FORM APPROVED
OMB NO. 1004-0137
Expires: January 31, 2018**SUNDRY NOTICES AND REPORTS ON WELLS**
*Do not use this form for proposals to drill or to re-enter an abandoned well. Use form 3160-3 (APD) for such proposals.*5. Lease Serial No.
NMNM59386

OXY USA Inc. respectfully requests to amend the APD for the following wells for BOP Break Testing.

REQUEST FOR A VARIANCE TO BREAK TEST THE BOP

Break Testing Procedures

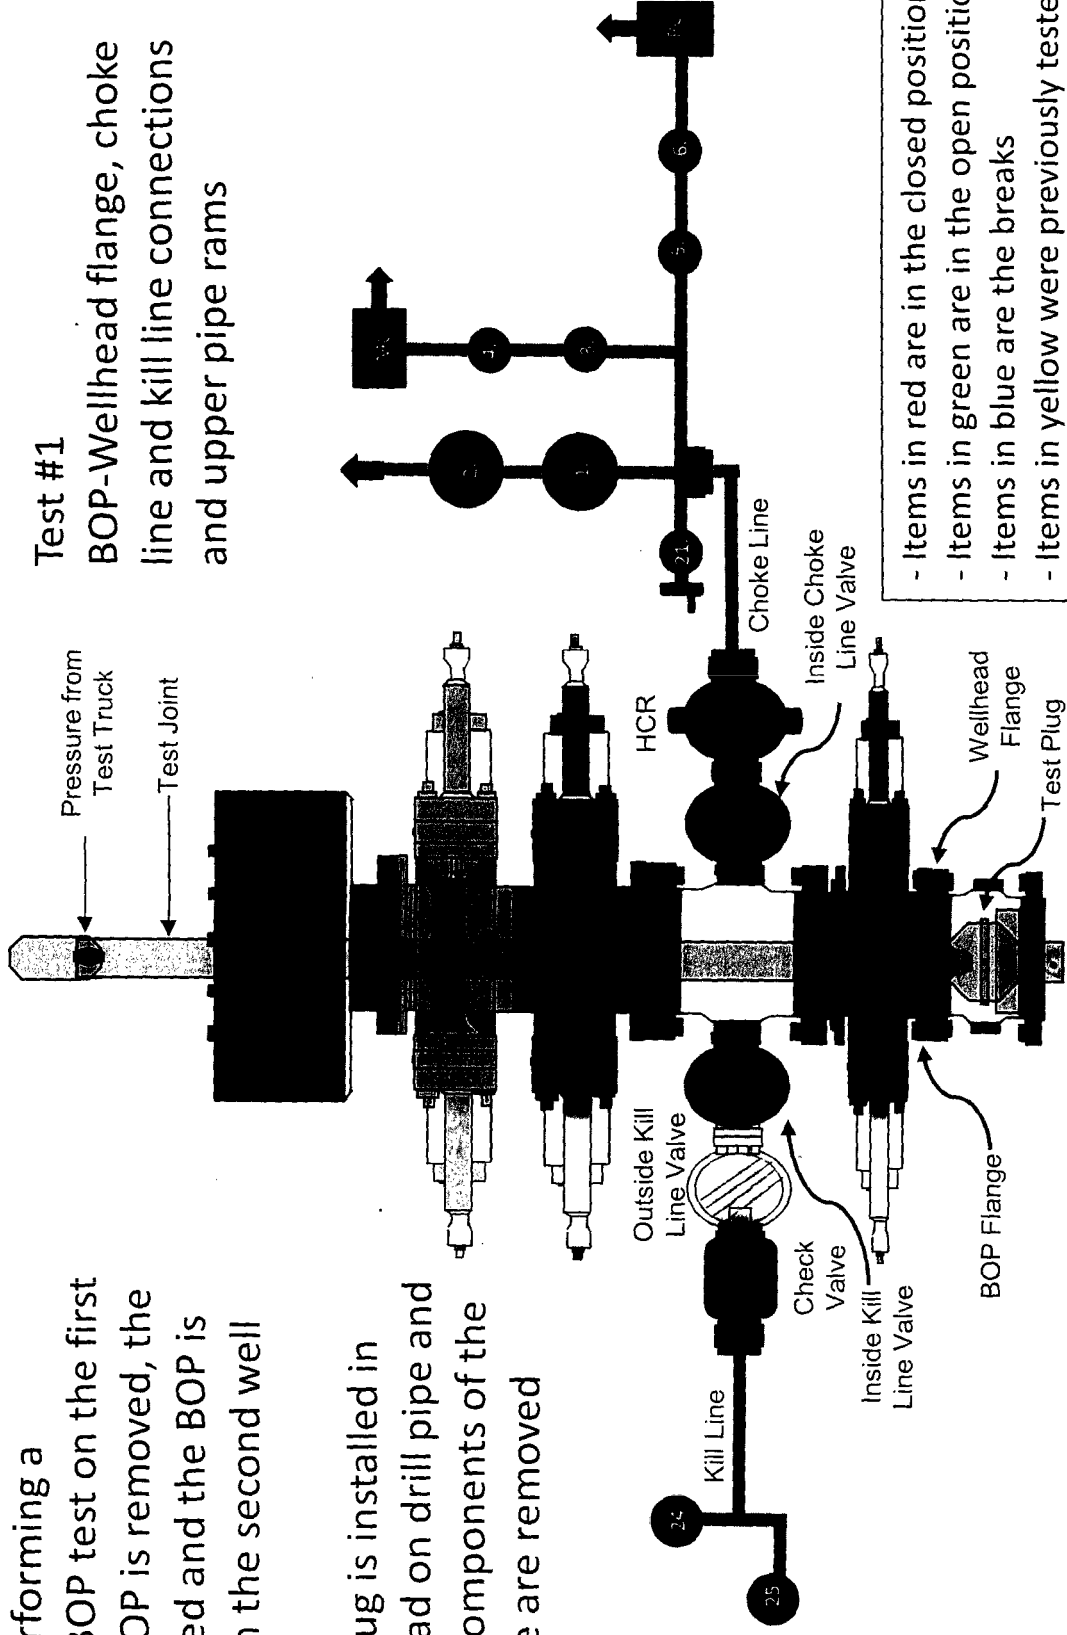
- 8) A shell test is performed against the upper pipe rams testing all three breaks
- 9) The internal parts of the check valve are reinstalled and the HCR valve is closed.
A second test is performed on them
- 10) These tests consist of a 250 psi low test and a high test to the value submitted in the APD or SN (e.g., 5000 psi)
- 11) Perform a function test of components not pressure tested to include the lower pipe rams, the blind rams and the annular
- 12) If this were a three well pad, the same three breaks on the BOP would be made and steps 4 through 11 would be repeated
- 13) A second break test would only be done if the third hole section could be completed within the 30-day BOP test window
- 14) If a second break test is performed, additional components that were not tested on the first break test will be tested

Second Break Test

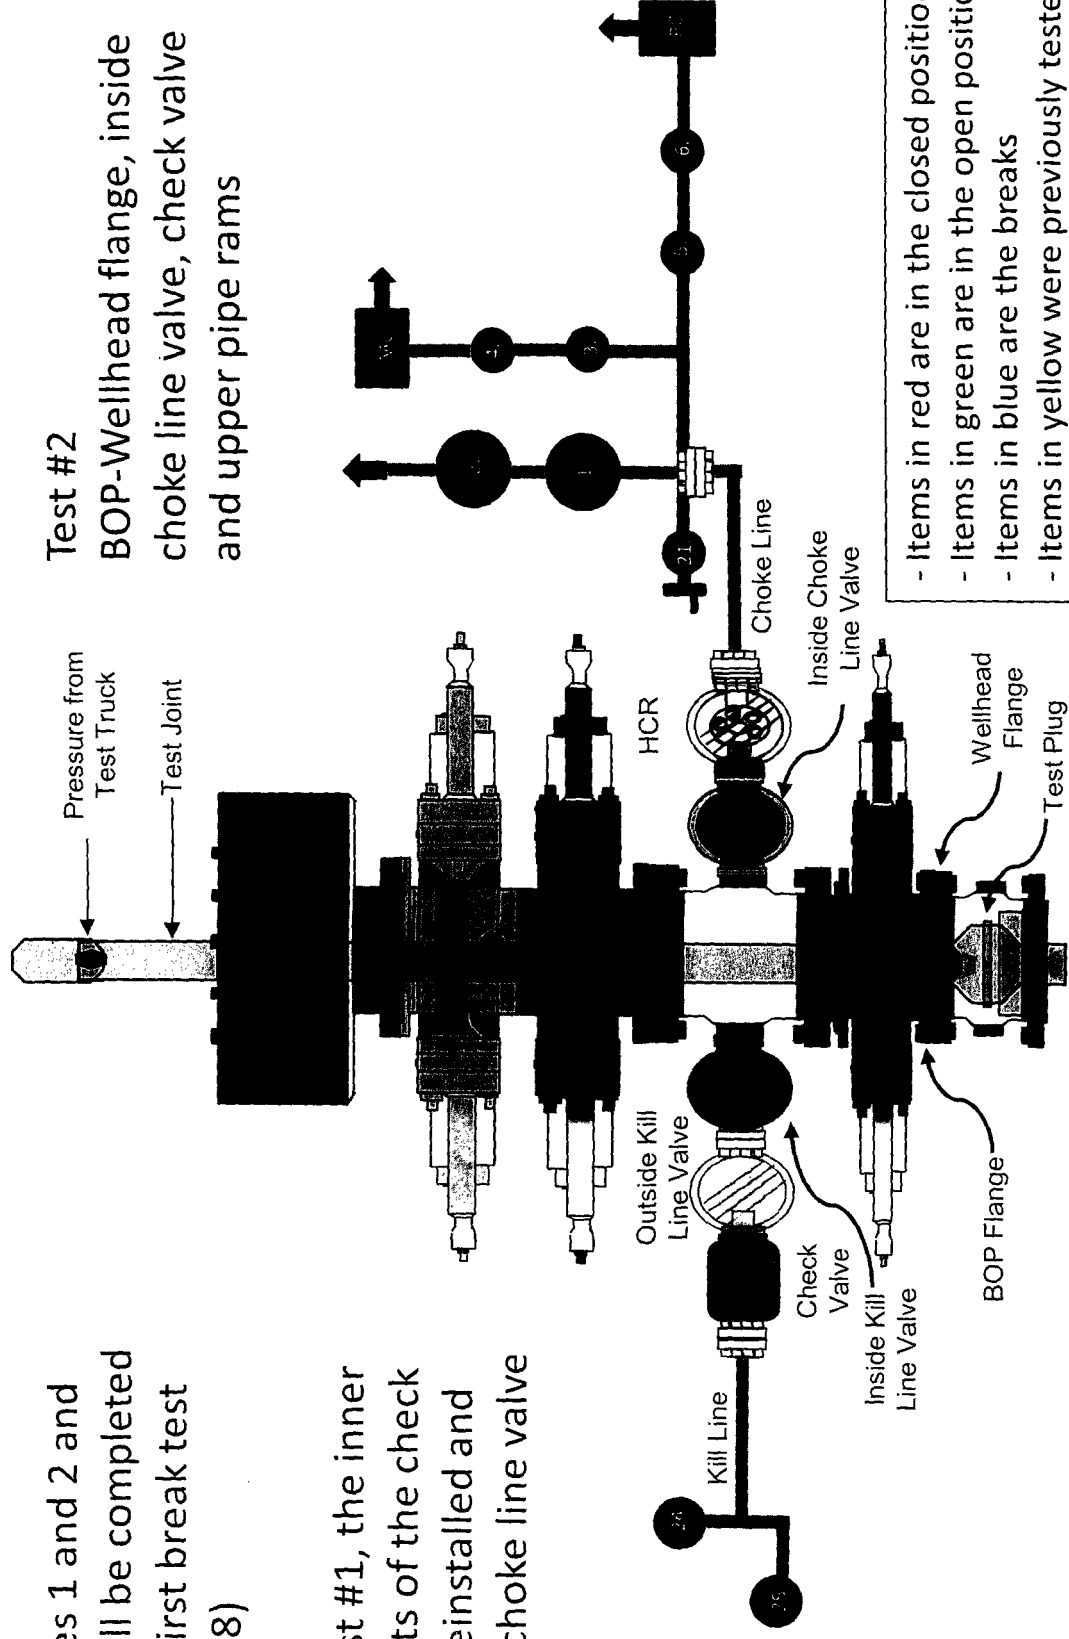
Procedures 1 and 2 and Test #1 will be completed as in the first break test (see slide 8)

3. After Test #1, the inner components of the check valve are reinstalled and the inside choke line valve is closed
